DEVELOPMENT REVIEW COMMISSION STAFF REPORT

CASE NO.: 22-32000003 PLAT SHEET: M-22

REQUEST: Approval of a special exception and related site plan to construct

a self-service express car wash.

SHEET TITLE: SITE PLAN

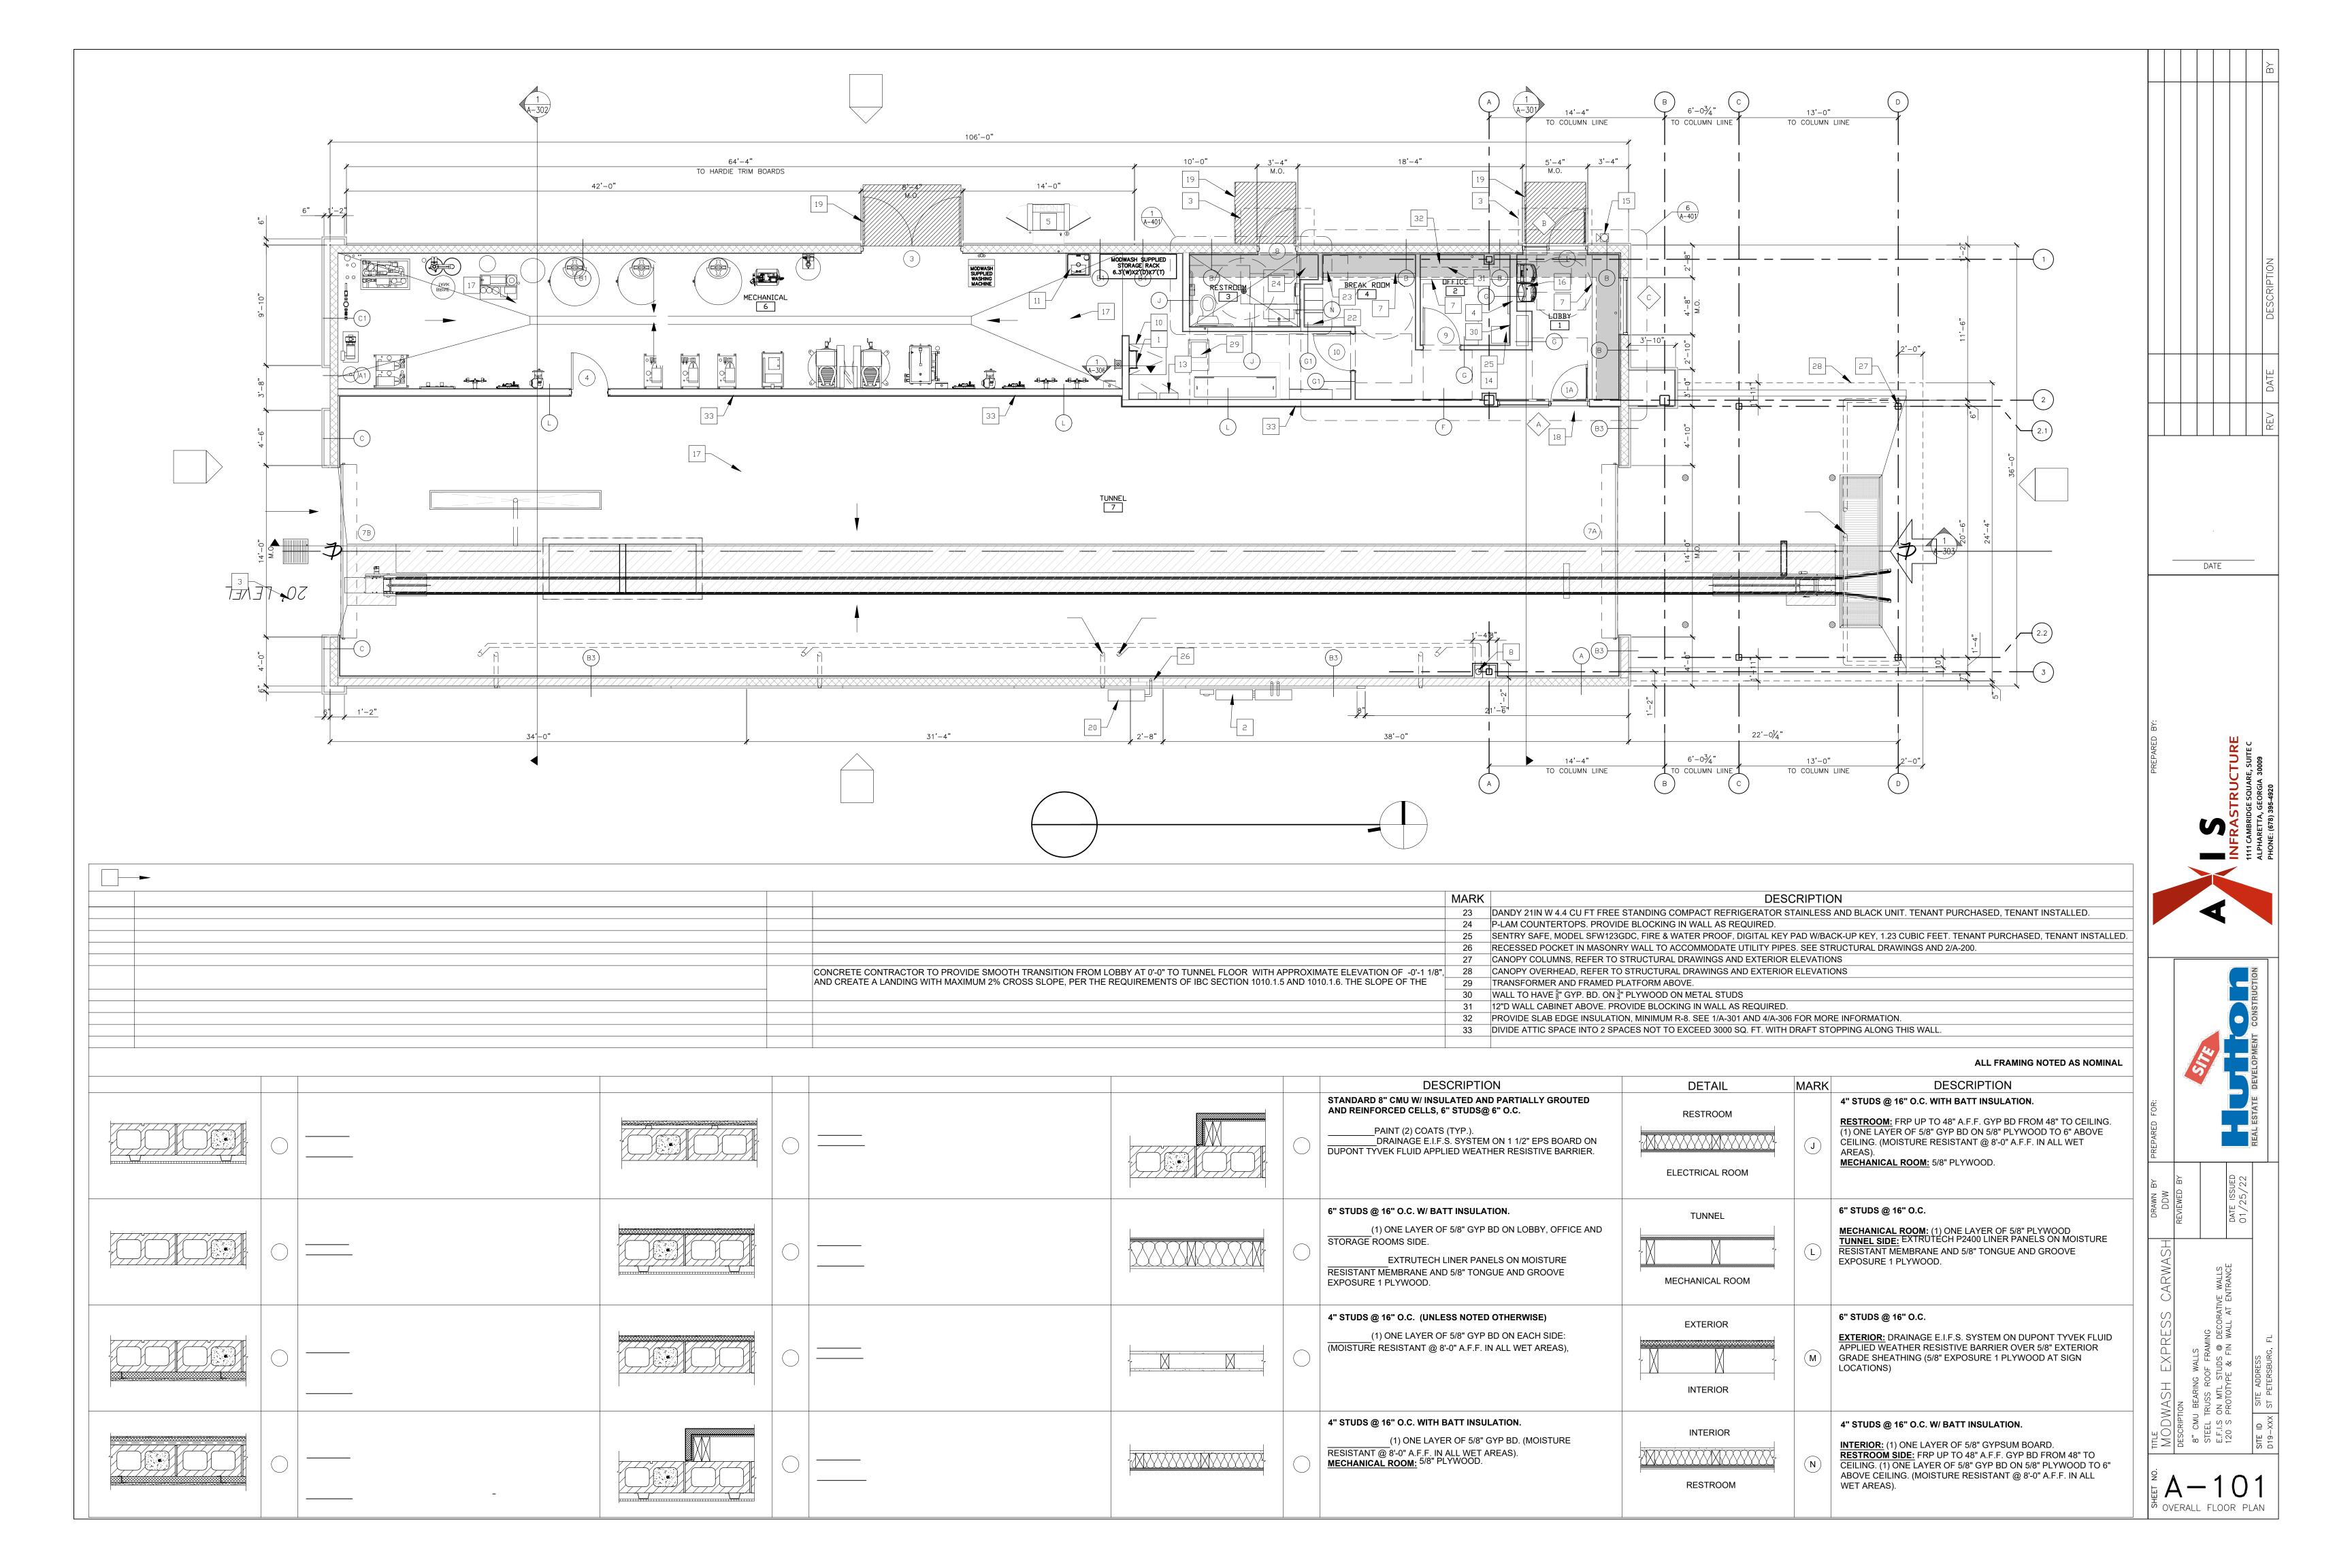
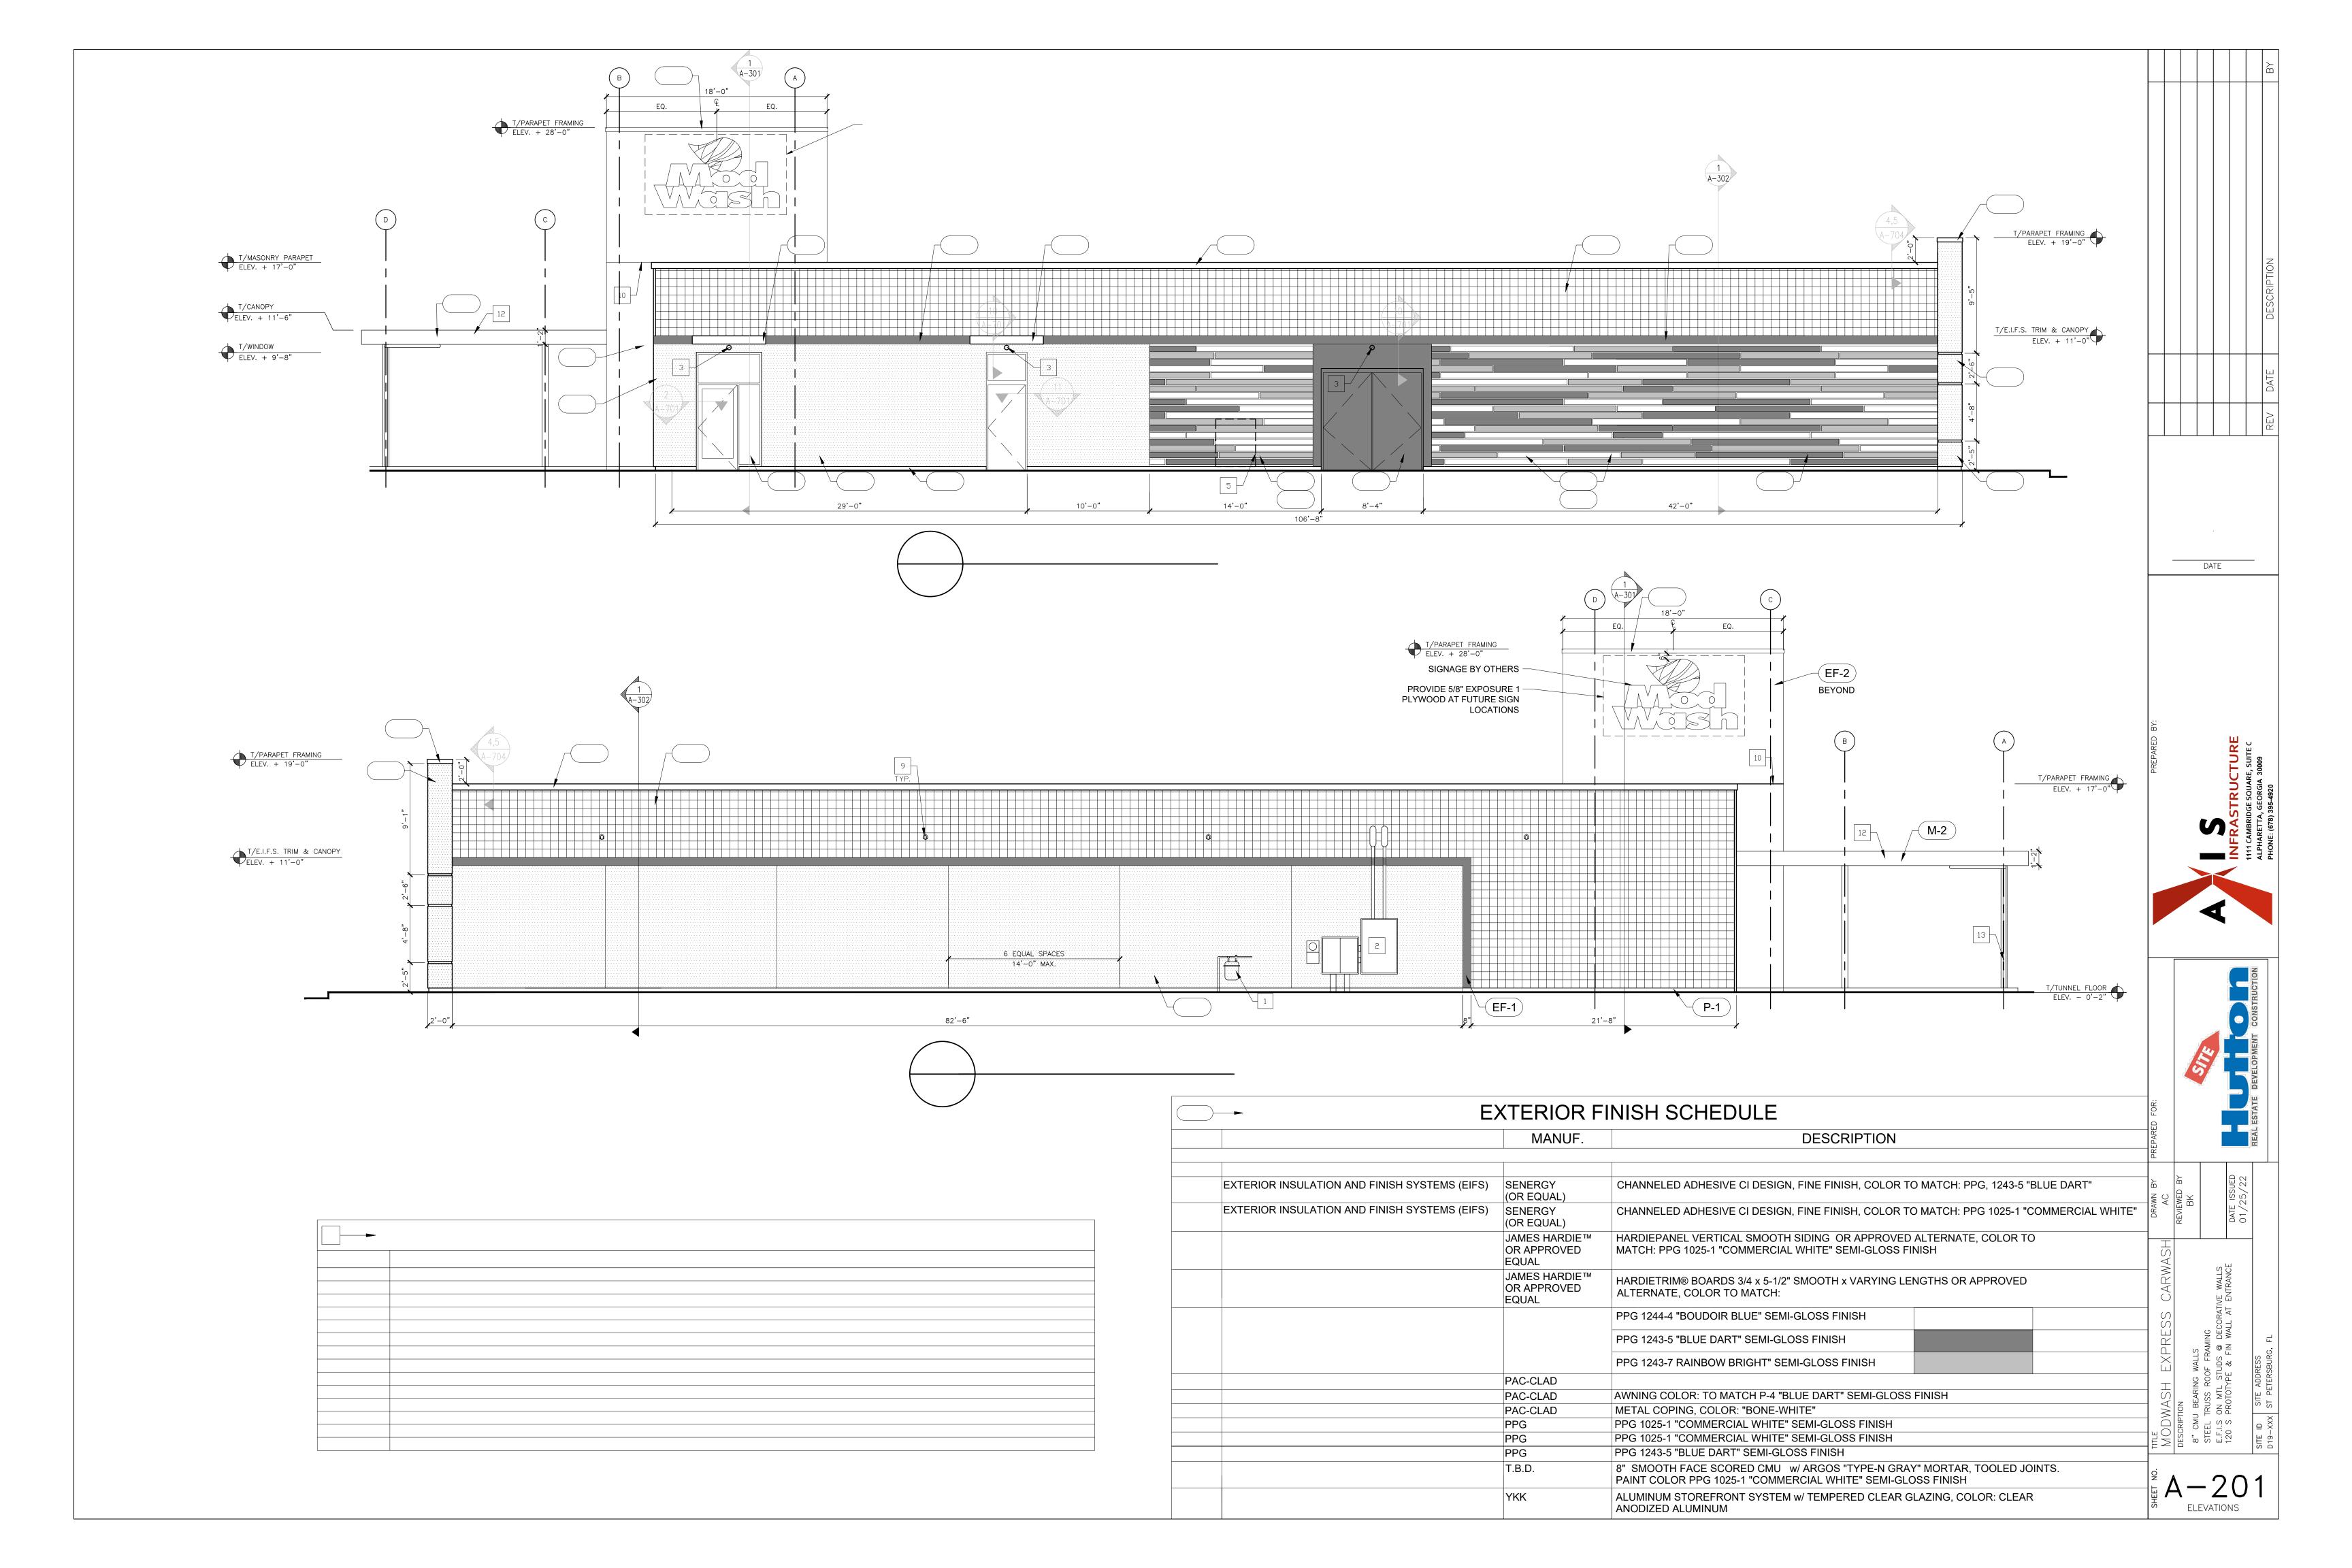
- 9. A minimum of 84 specimen inches shall be preserved on-site as required by Section 16.40.060.2.1.3. The tree disposition plan included with the application notes only 73 specimen inches to be preserved.

- 10. Shrubs shall be installed around the exterior perimeter of the ponds.
- 11. The parallel parking spaces shall have a minimum length of 23 feet.
- 12. The dumpster compound shall have opaque gates.

- 15. Bicycle parking shall comply with Section 16.40.090.4.1.
- 16. The transformer shall not be visible from ROW. The applicant shall relocate or provide decorative screening to shield from view.

Section 16.20.090.7 of the City Code notes that emphasis is placed on creating a positive experience for the pedestrian, which is the base of the transportation hierarchy. The sidewalk pavement on 39th Avenue North shall be continued through the driveway to clearly delineate the pedestrian network. The driveway on 40th Avenue North should be designed to discourage wrong-way entry from 40th Avenue North. If you have any questions about this memorandum, please call me at (727) 893-7151.
